> DESIGNED EXCLUSIVELY FOR: LEO & ROBBIE BROOKS XXX SR 47 LAKE CITY, FL 32025

**Review for Code Compliance** Universal Engineering Science

## DESIGN CRITERIA DRAWING SCHEDULE DRAWING DATA ALL DRAWINGS, DETAILS, SQUARE FOOTAGE PLAN NAME: THE MADISON **ROOF PLAN** TITLE PAGE AND SPECIFICATIONS ARE DATE DRAWN: 11/15/2021 **ELEVATIONS** TYPICAL DETAILS FIRST FLOOR: FRONT PORCH: DESIGNED IN ACCORDANCE 102 sq ft w/ FLORIDA BUILDING CODE SECTION DETAILS DRAWN BY: JLB FLOOR PLAN SECOND FLOOR: REAR PORCH: 398 sq ft (FBC) 7th EDITION (2020) ACI-318,ACI-ASCE 530. 245 sq ft | GARAGE: ELECTRICAL PLAN RESERVED BONUS RM: 580 sq ft ALL CONSTRUCTION SHALL MEET OR EXCEED ALL PLUMBING PLAN **RESERVED** FINISHED BASEMENT: OTHER: APPLICABLE STATE, & LOCAL ARCHITECTURAL DESIGNER SIGNATURE FOUNDATION PLAN BUILDING CODES RESERVED 2370 sq ft | TOTAL U/R: TOTAL H/C: 3650 sq ft

FLOOR PLAN

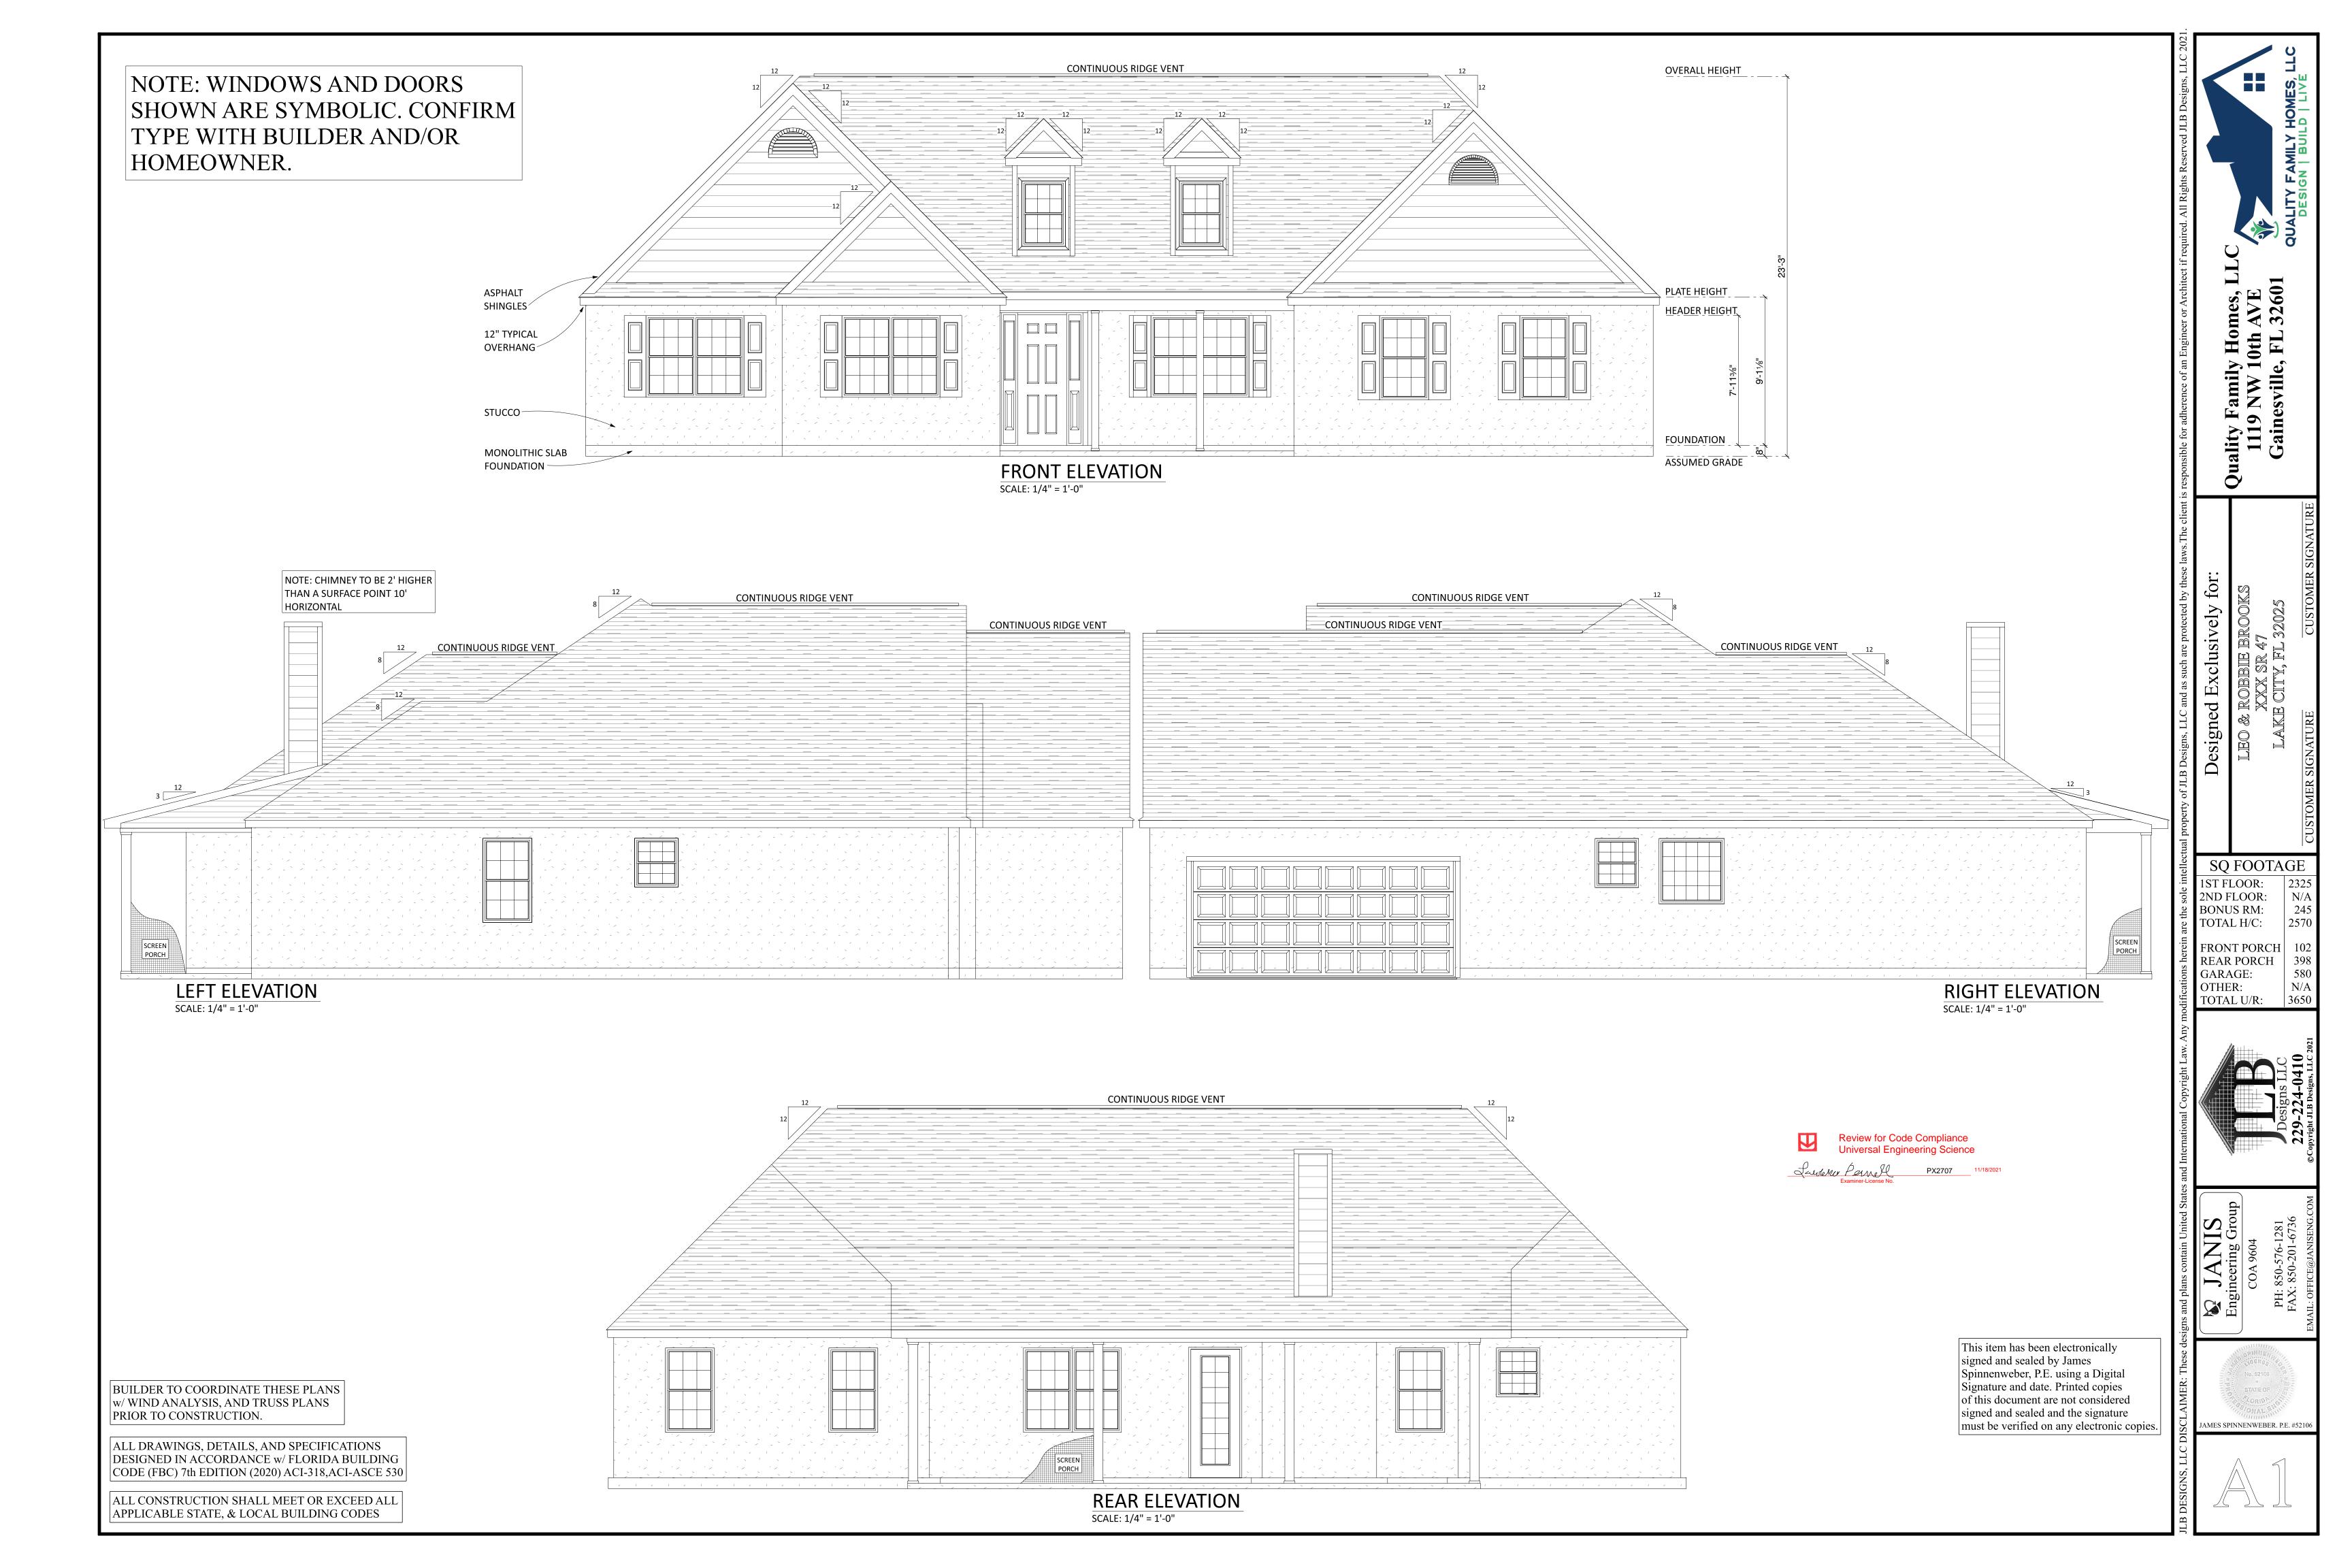
Provide at least one full bathroom with 29" clear opening doors for accessibility per FBC Stair winder per FBC R311.7.5.2.1.
